TOWN OF WAPPINGER

PROJECT NAME:	Jiffy Lube Multi-Care		
MEETING DATE:	May 16, 2022		
ACCOUNT NUMBER:	21-3448 (Site Plan) and 22-4095 (Special Use Permit)		
DATE PREPARED: May 9, 2022

Jiffy Lube Multi-Care
Amended Site Plan and Special Use Permit Review
Tax Parcel #657-02-653974
CPL # 14926-00050

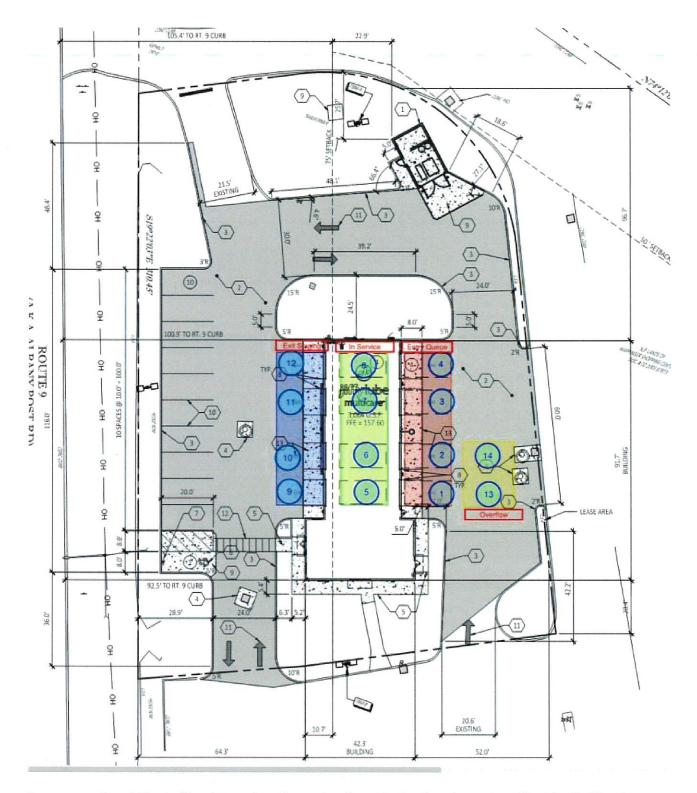
The site is designed to accommodate up to 12 cars in normal operation without impacting site circulation. four cars can queue in front of the bay awaiting service, four cars can be in service, and four cars can queue outside of the bay as customers pay which allows for the next car to enter the building. On occasions where cars stack beyond 12, the primary bays would be #1 and #2 which also have the quickest service. The overflow stack is not anticipated to impact adjacent parking circulation. (Diagram on next page).
